Stannah Lifts Technical Bulletin - Safety

Issue No: M7 Date: 18/01/01 Page 1 of 1

LIFT TYPE:- STANNAH STAIRISER

LANDING ZONE DETECTION SWITCH

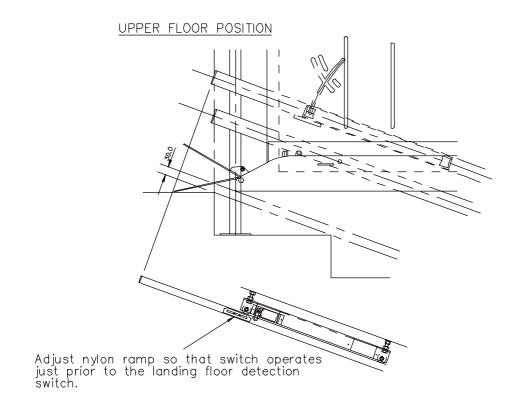
As from 02/01/01 a design change has been made to the Stannah Stairiser to include a landing zone detection switch. This is shown below:

The landing zone switch is fitted to ensure that power is not available to the barrier arm circuit in between floors. This switch should therefore be activated just before the landing detection switch (located in the top rail) is operated.
